| CELL :-A352 | CELL NAME:-Drum Change | MACHINE / STAGE :-Molding | | | | | OPERATION :- Molding | | | | |

KAIZEN THEME :-To eliminate hole block problem in A352 Drum change.

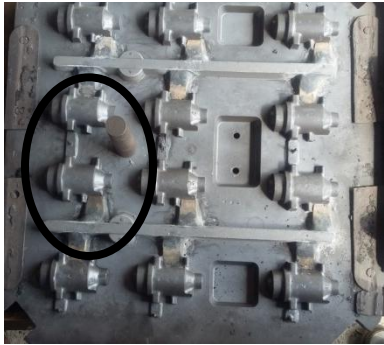
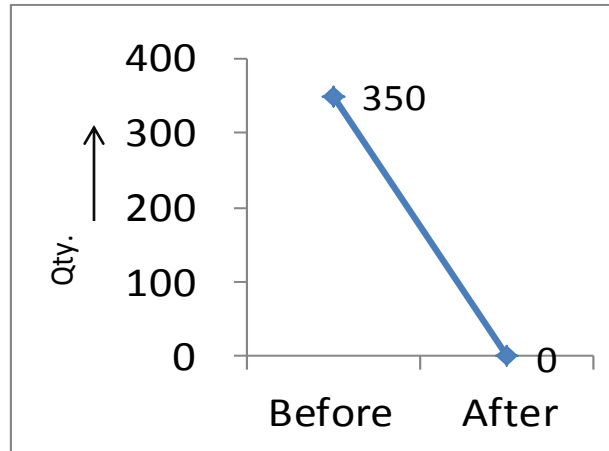
•PROBLEM / PRESENT STATUS :-hole block in A352

Why1:-Hole block in A352.

Why 2:- Core Damage.

Why3:- Core locking not available in pattern.

Why4:-Due to touch print of core.

ROOT CAUSE :-Touch Print Of Core.

COUNTERMEASURE:-Core locking provided in pattern to lock the core.
